DELAWARE RIVER AND BAY AUTHORITY

WILMINGTON AIRPORT

ADDENDUM NO. 1

DEPARTURE LOUNGE CONCESSION AREA

C-A-420R1

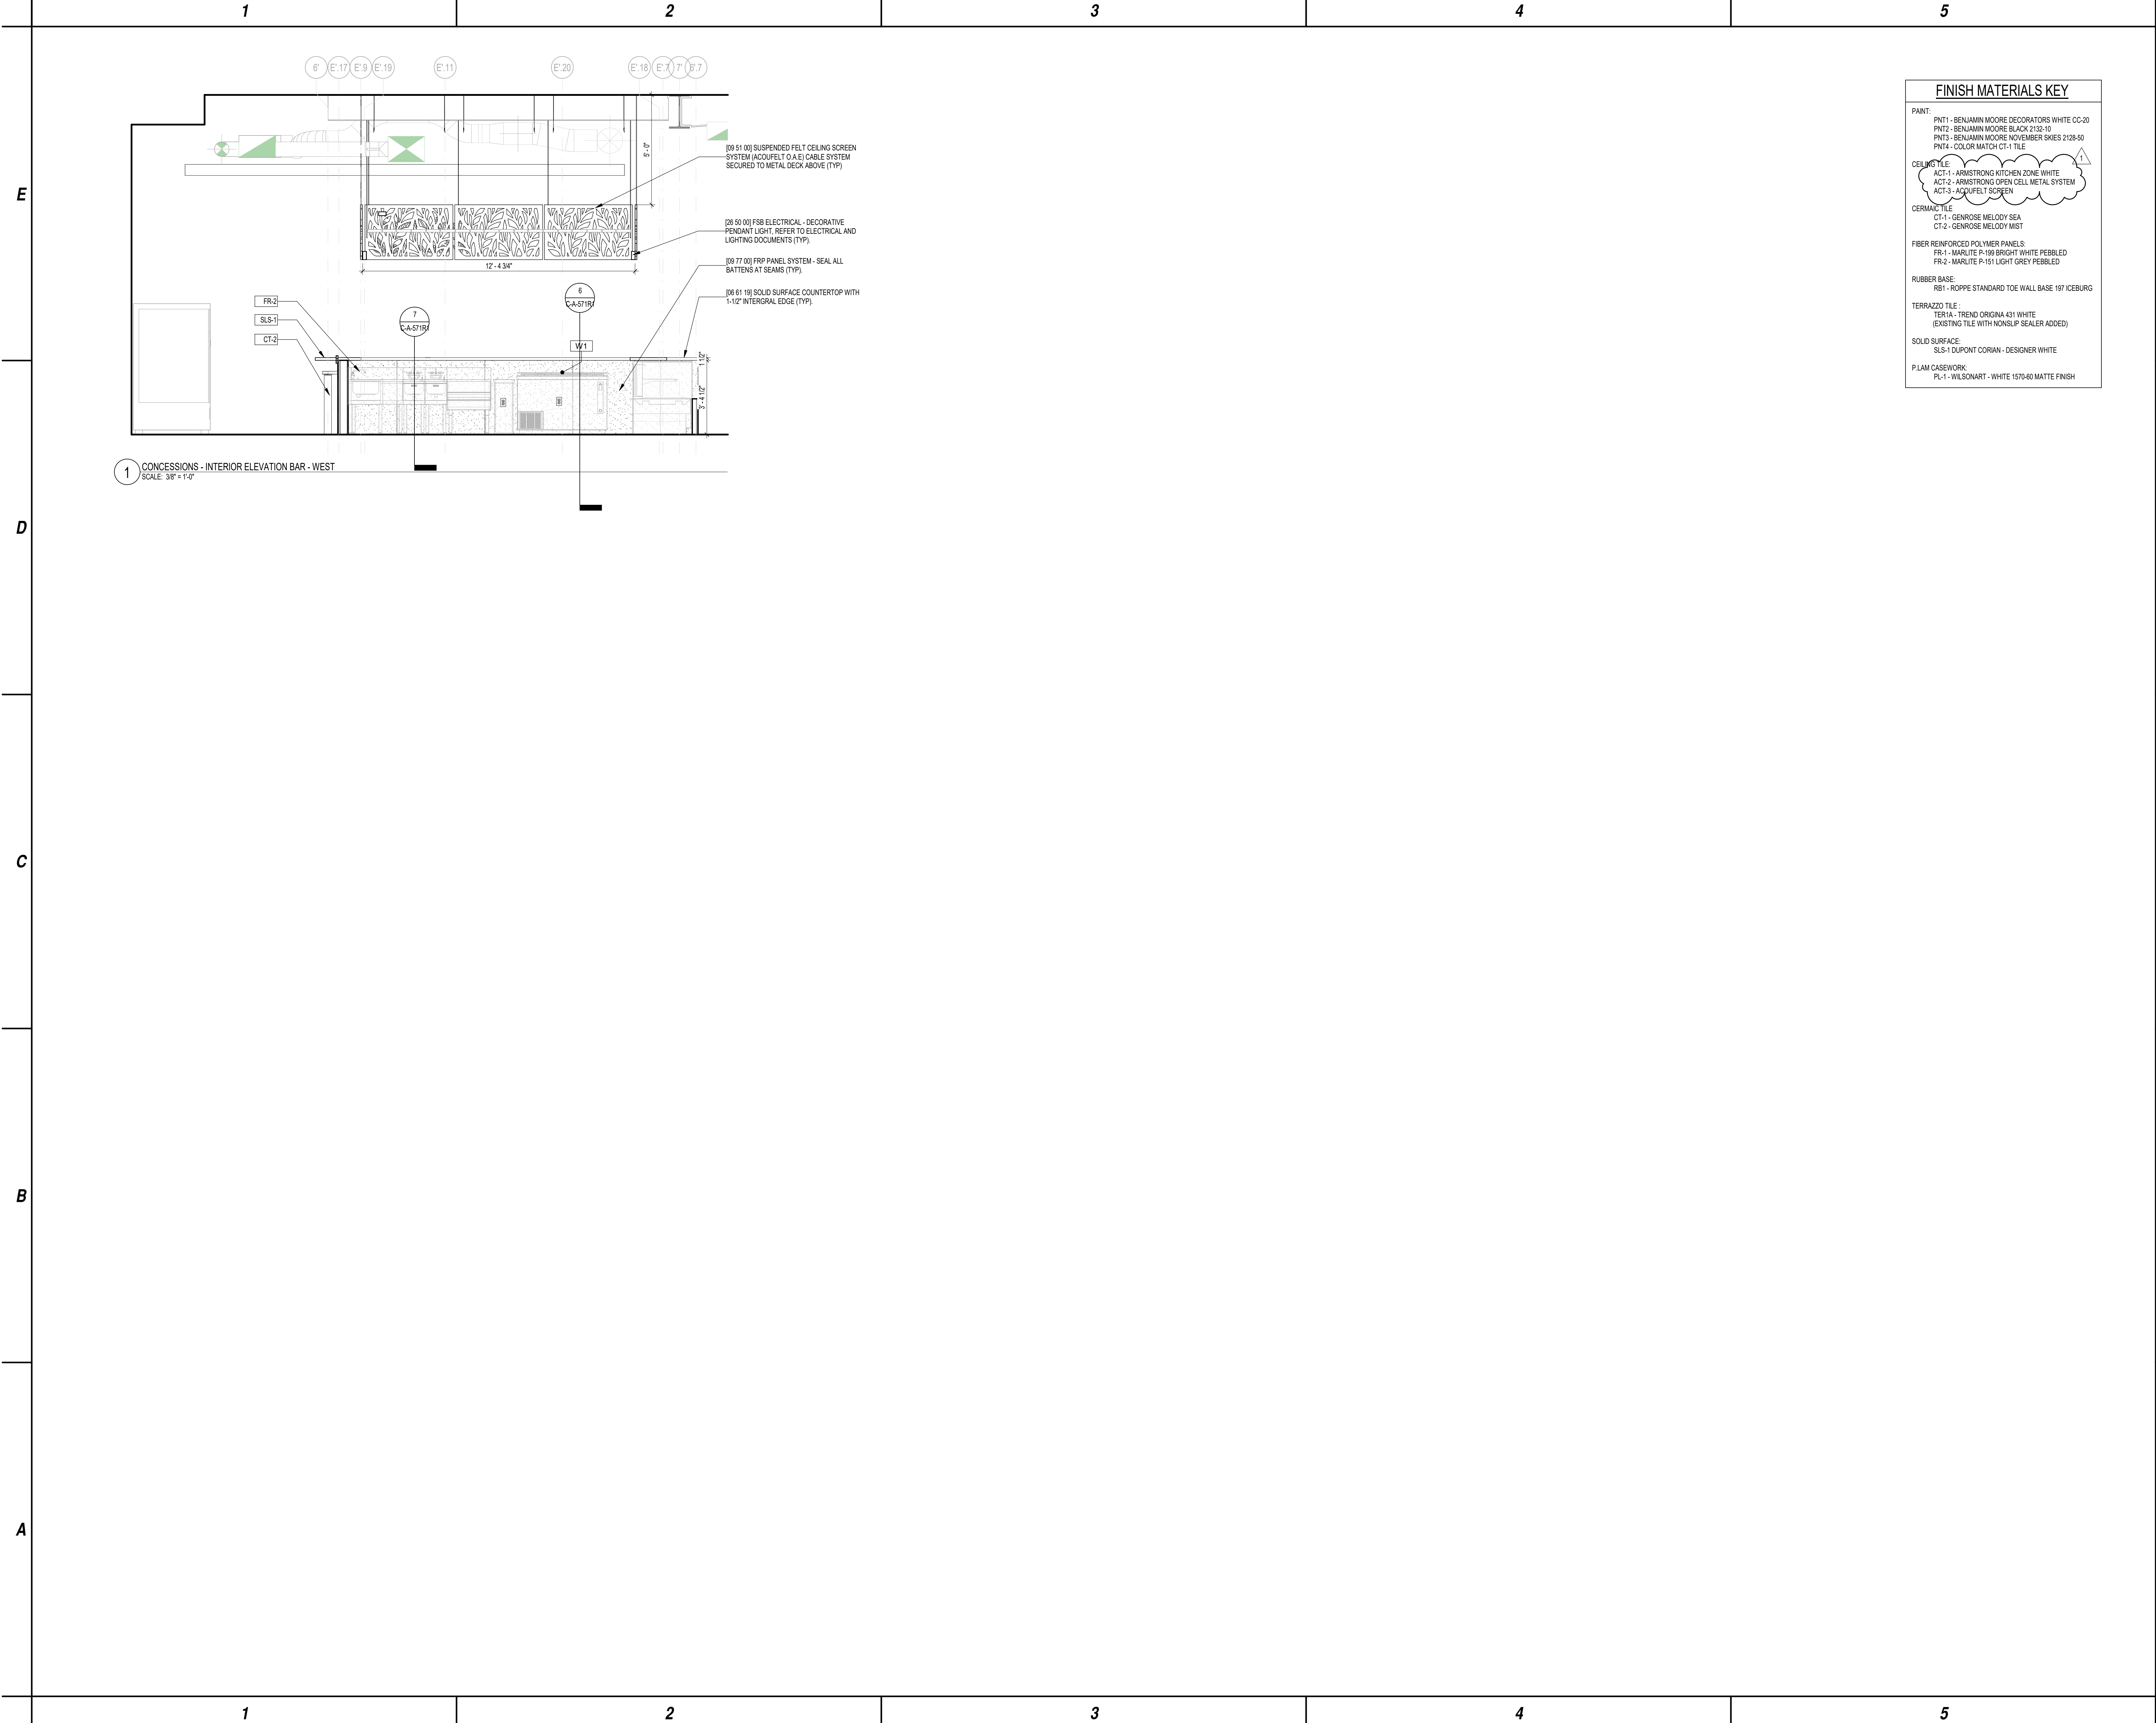
- A6. See Amendment No. 1. Corian; thickness dimensions on Plan Sheet A-571 have been updated.
- Q7. Plan Sheet A-100 has reference tag as #5 but there is not an elevation 5 on any of the plan sheets. We need the elevation 5 to see what you want for millwork under the countertop. Designer White is only available as a solid surface color. DuPont only offers ¾" thick solid surface in glacier white and cameo white, which is non-stock / special order / available in pallet quantities of 7 sheets. The sheet size is ¾" x 30" x 144". Otherwise, Designer White is available in ¼" x 30" x 98" sheet size, but this material is also non-stock / special order / available in pallet quantities of 16 sheets.

- A7. See Amendment No. 1. Elevation 5 in Plan Sheet A-420 has been updated to include the millwork shown in the corresponding detail 2 in Plan Sheet A-571. Refer to A6 regarding solid surface.

C-A-542R1

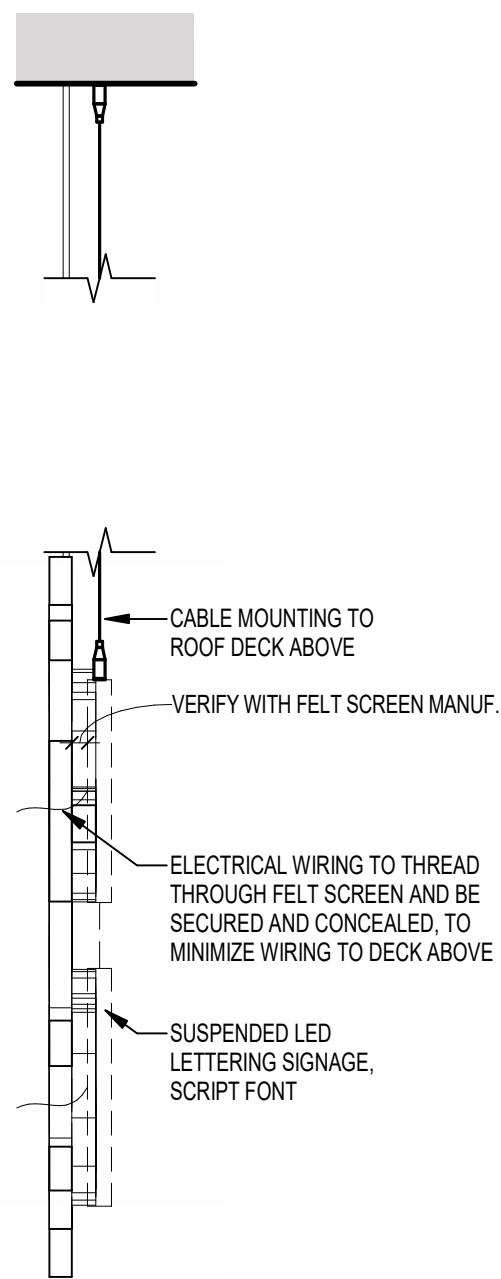
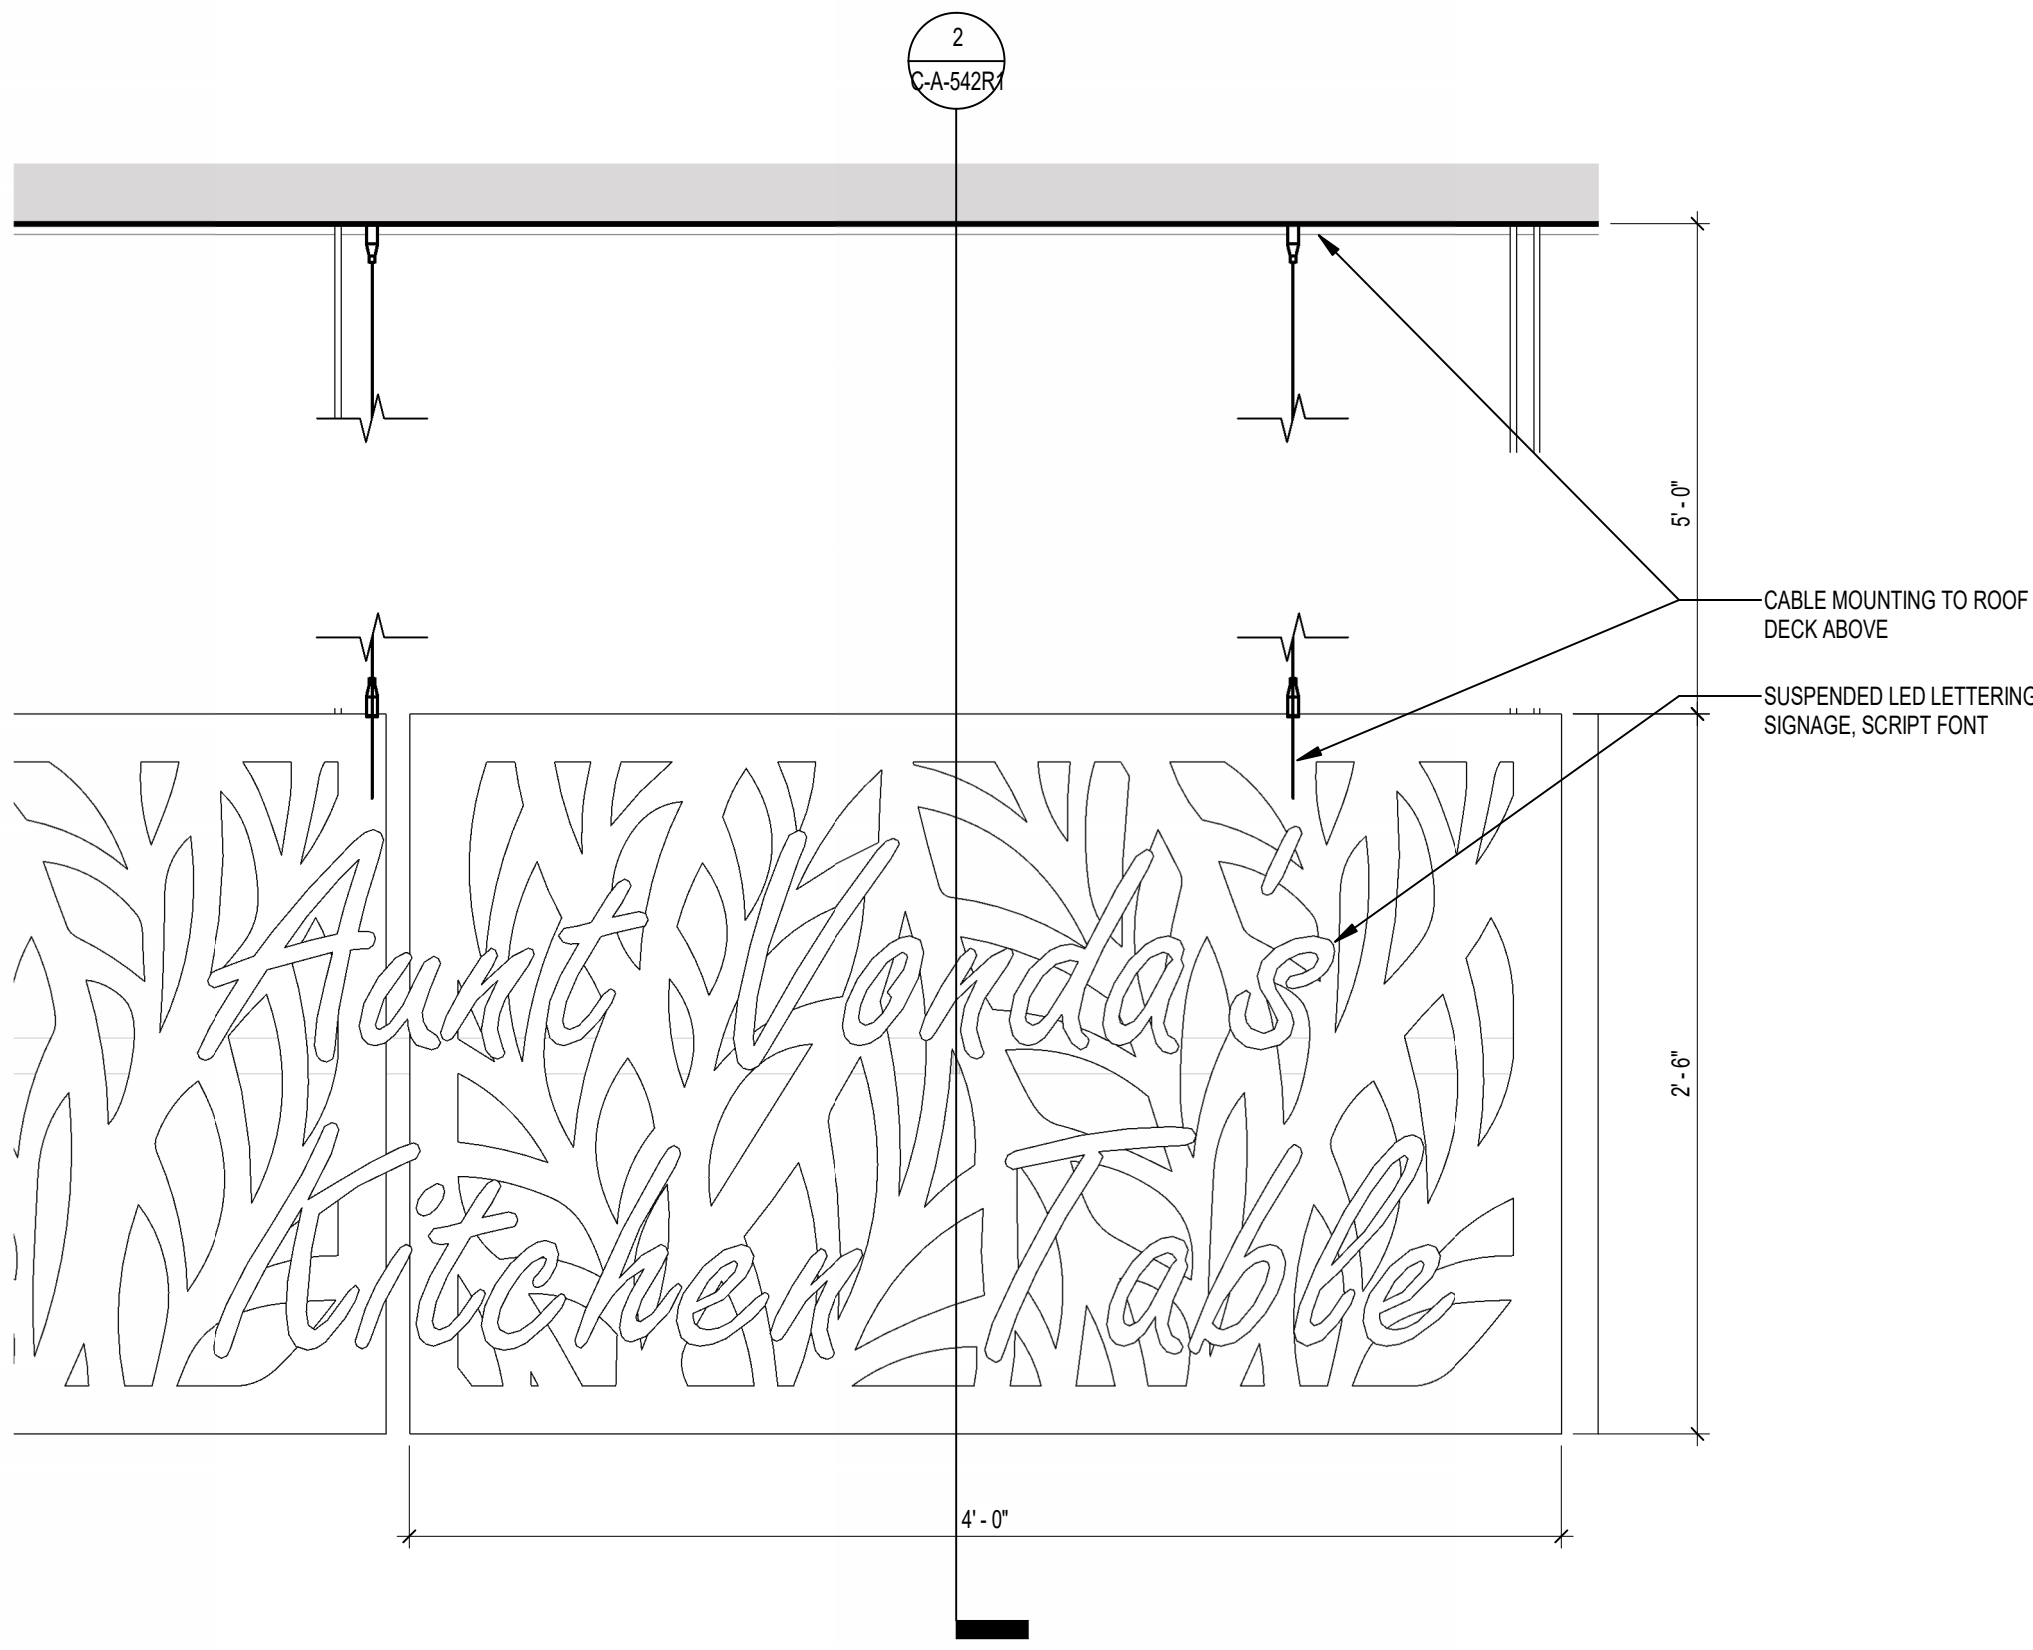
- Q3. Is the suspended LED lettering signage with script font as shown on Plan Sheet A-542 to be supplied by the Contractor or the Authority?
- A3. It will be furnished and installed by the Authority.
